1415 N TEJON COVERED DECK ADDITION – REPORT OF ACCEPTABILITY Historic Preservation Board - June 3, 2024

Staff Report by City Planner: William Gray

File Number	Application Type	Decision Type
HIST-24-0005	Report of Acceptability	Quasi-Judicial

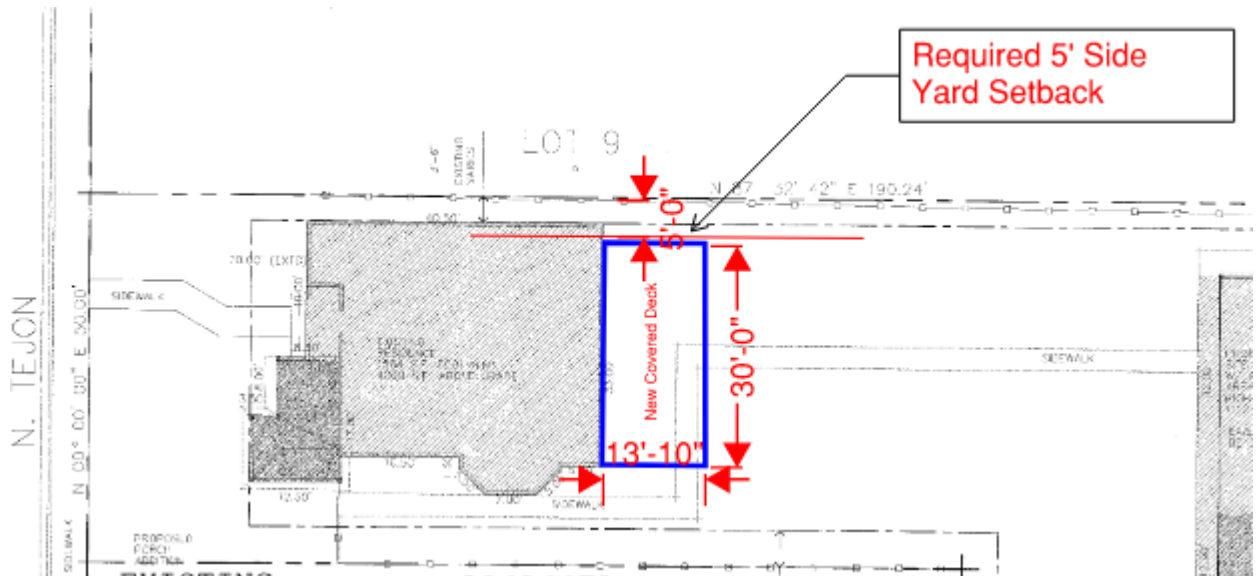
The Applicant has submitted a Report of Acceptability for a covered deck addition on the rear of the existing house located at 1415 North Tejon Street (see "Attachment 2- Project Statement and Covered Deck Plans"). The proposed deck is 415 square feet. It has been aligned with the south exterior wall of the home to meet the side yard setback standards.

The new back porch is 1-story in height and is designed with a mansard roof type. It is like the roof type that exists on the east elevation of the home. The proposed height, width and depth are compatible with the main house, and the simple design of the addition respects the character of the historic home. The rear elevation was altered sometime in the past as this home originally had a back porch. The new back porch is open on the rear and closed-in on the sides. The framing of

The new design for the rear porch is open, with appropriate scale and massing to the primary structure and its framed openings on the rear and side elevation fit with the window pattern and shapes that exist with this historic home. Most importantly, the addition has minimal visual impact on the existing structure.

- 1) Final architectural plans and elevation, and site plan are submitted showing exact location of the rear porch, roof type, and specifications for exterior material and colors. The plans are to be provided in pdf format, drawn to scale and 24" X 36" sheets.
- 2) The above referenced plans are to be submitted and stamped prior to any final inspection for the rear porch.
